City of Ryde

**EXHIBITION OF ENVIRONMENTAL ASSESSMENT FOR CONCEPT PLAN
AND STAGE 1 PROJECT APPLICATION FOR BUILDING ENVELOPES
AND OPEN SPACE, AND RESIDENTIAL, ANCILLARY COMMERCIAL
AND RETAIL USES WITH ASSOCIATED INFRASTRUCTURE,
MEADOWBANK EMPLOYMENT AREA, MEADOWBANK AND RYDE
(MP09_0216 AND MP09_0219)**

Executive Summary

Attachment 1

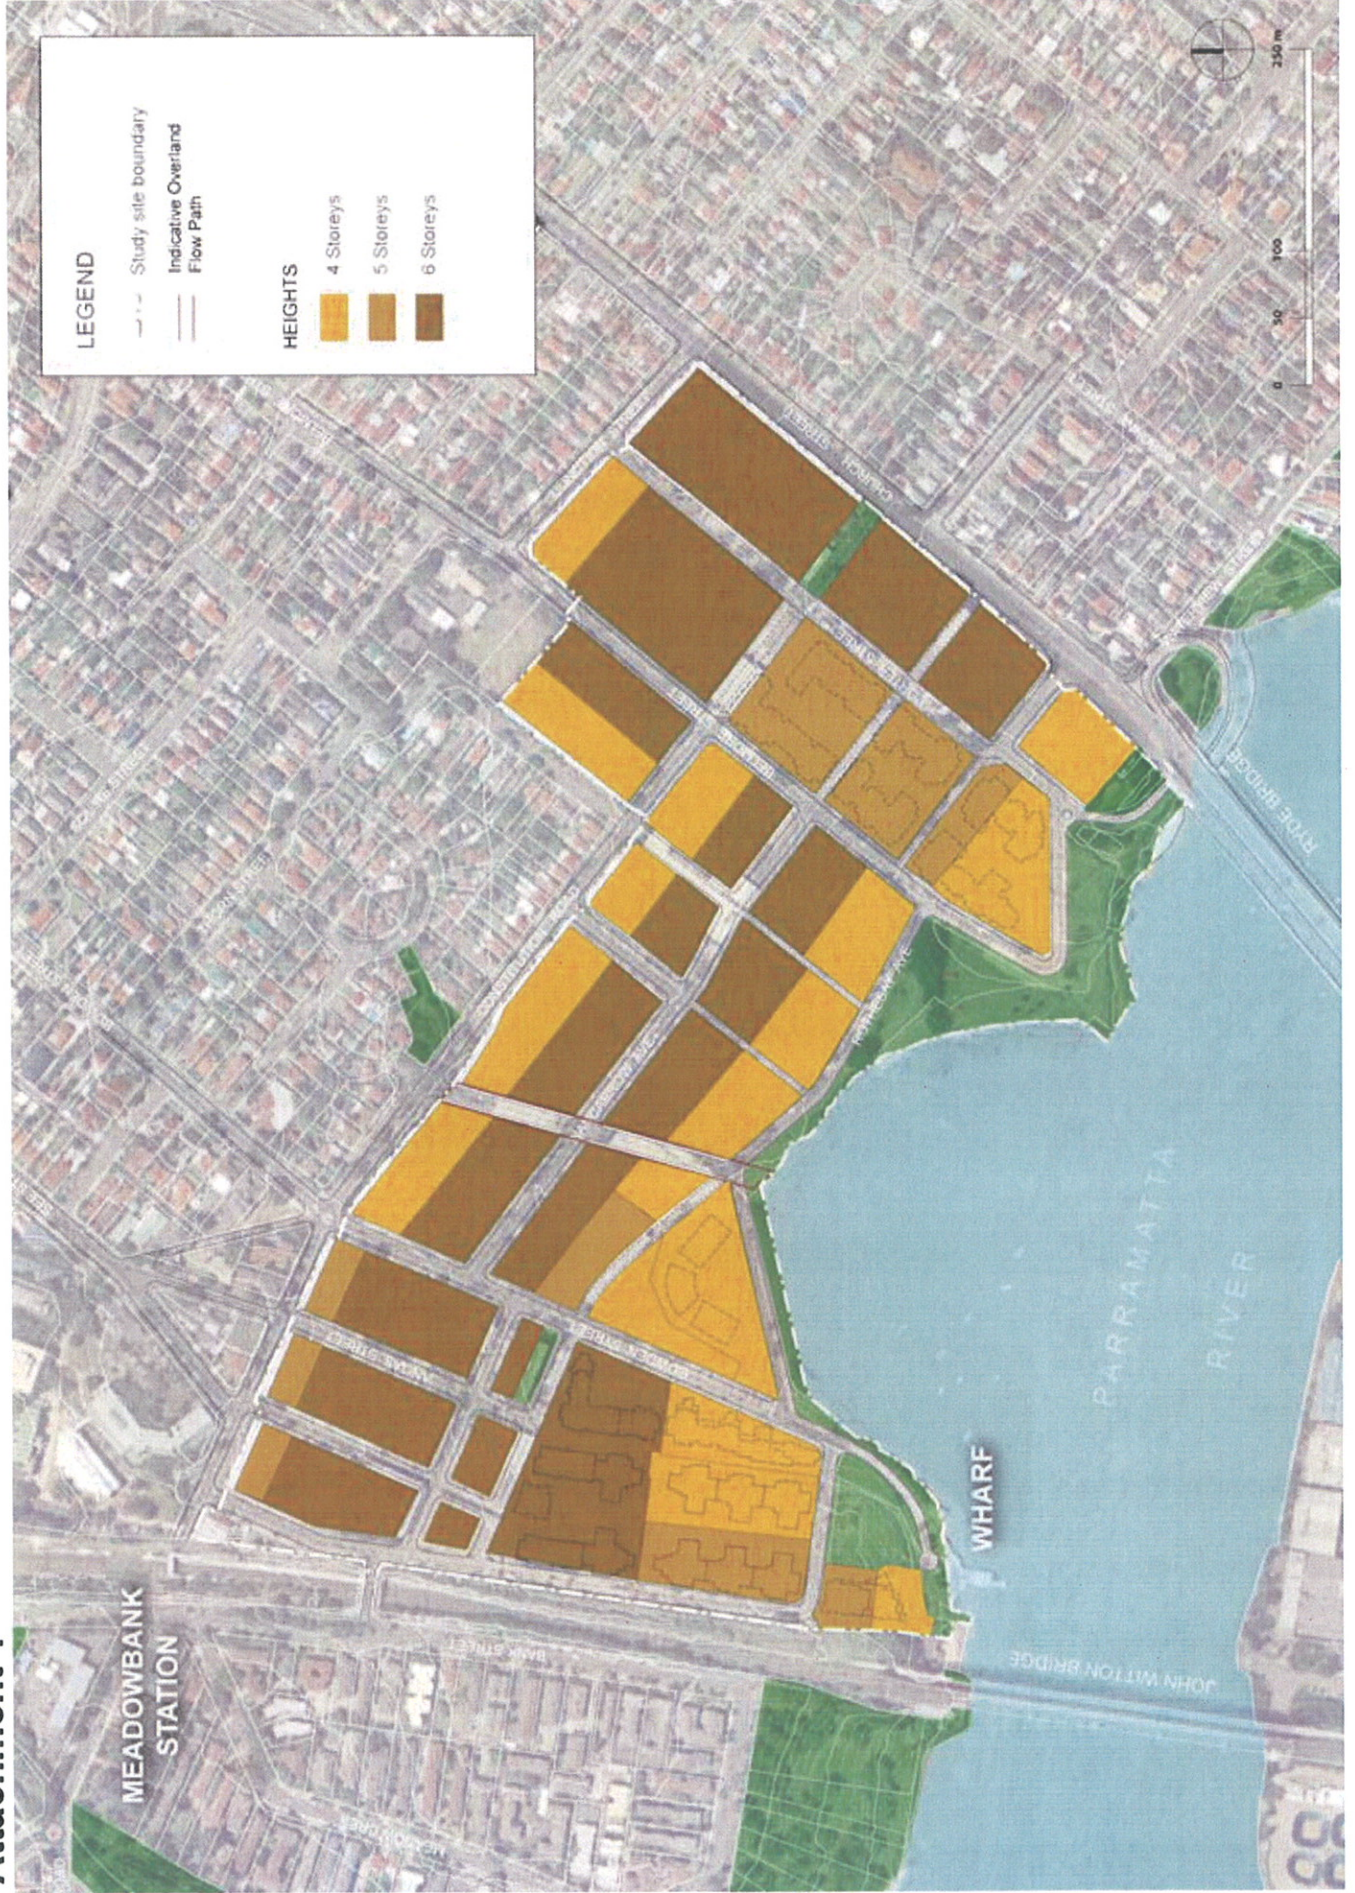
The proposal allows for a substantial increase in height against those currently permitted under Council's own controls. Council is currently revising the planning controls applicable with to the *Meadowbank Employment Area* (MEA). These new revised controls will be detailed within the new forthcoming Comprehensive Local Environmental Plan and will be based on the heights detailed under Council's *Local Planning Study*. **Attachment 1** details the heights proposed under the *Local Planning Study*.

Attachment 2

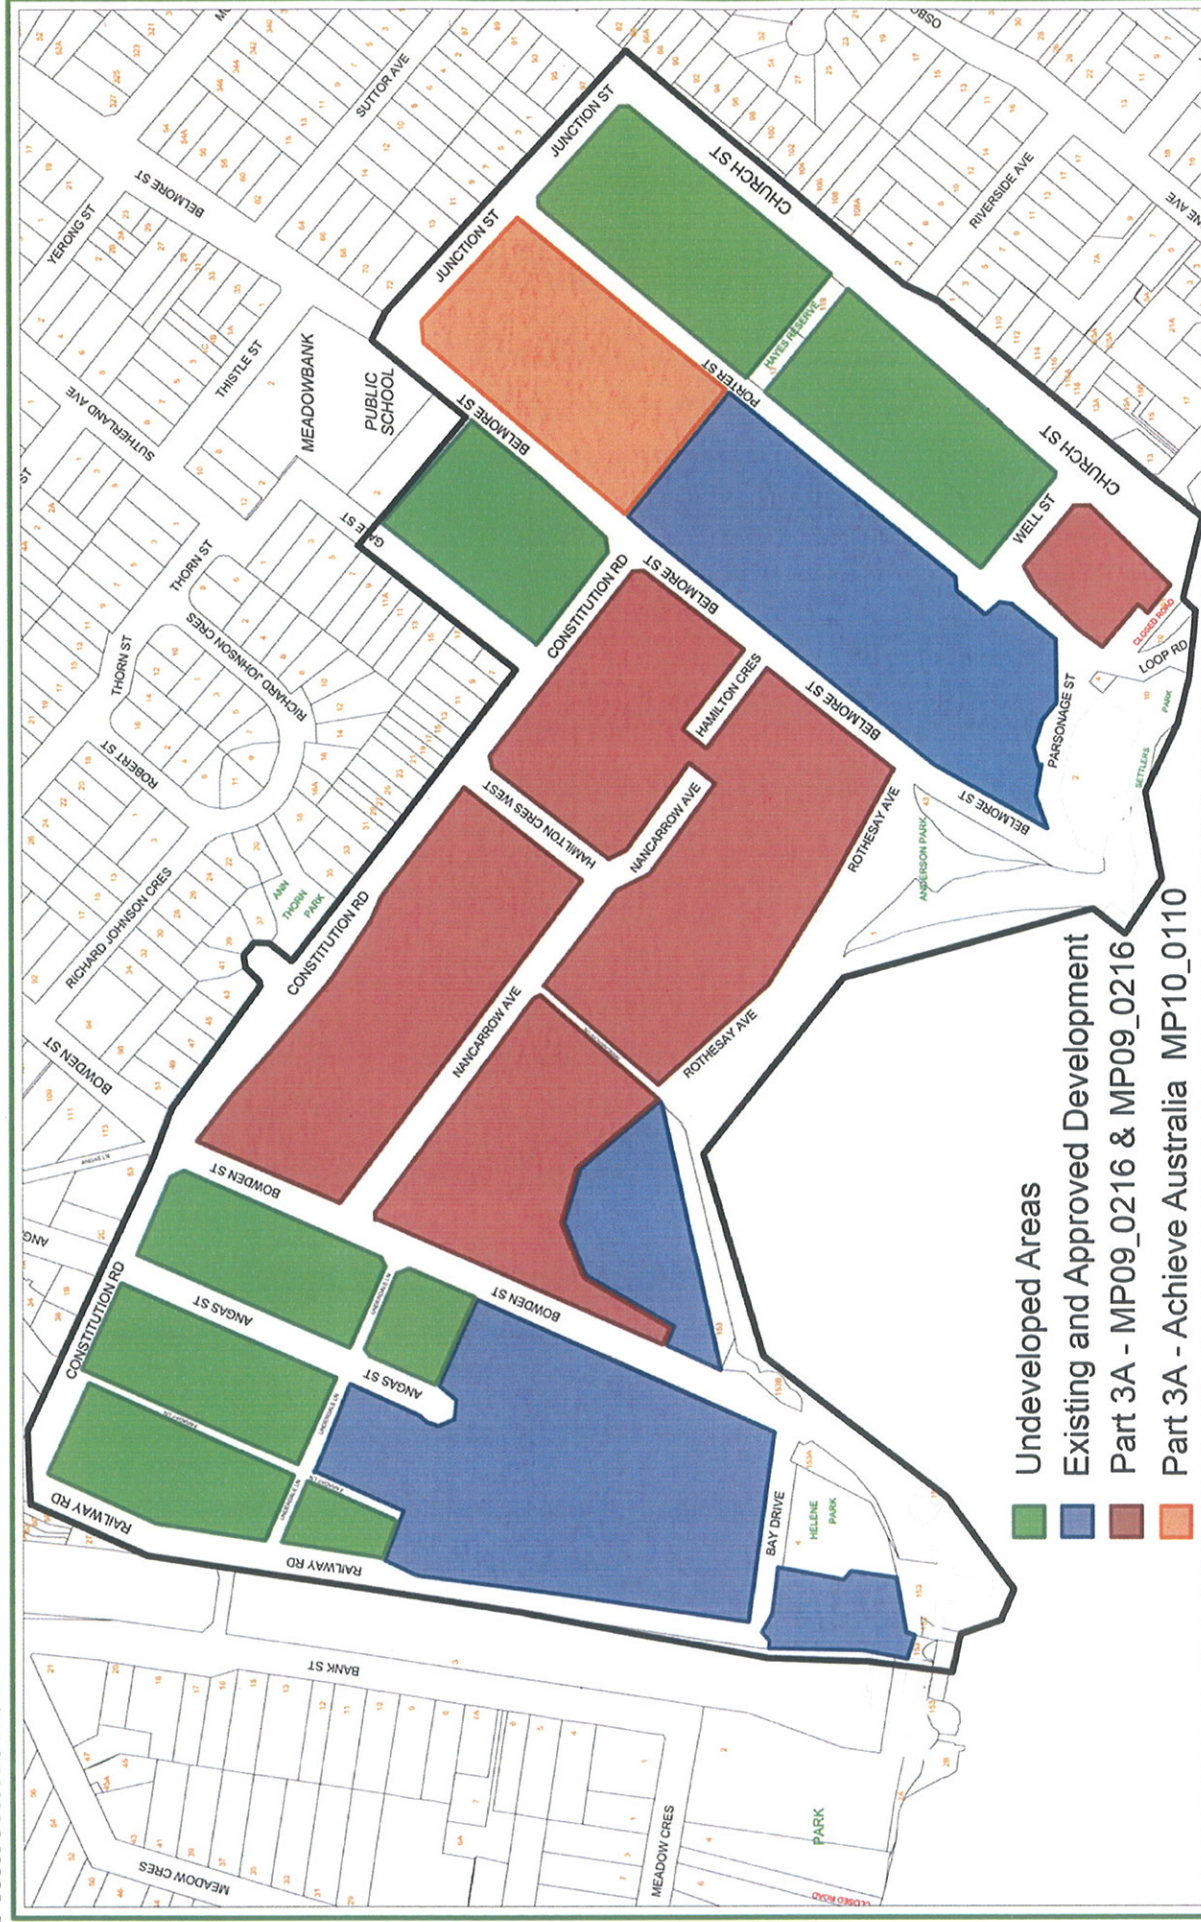
From Attachment 2 it can be seen that a large portion of the entire MEA area remains undeveloped. These areas consist largely of industrial, commercial and low scale residential uses. This is of substantial concern given the significant increase in development proposed within the Concept Plan area against Council's current and intended future controls.
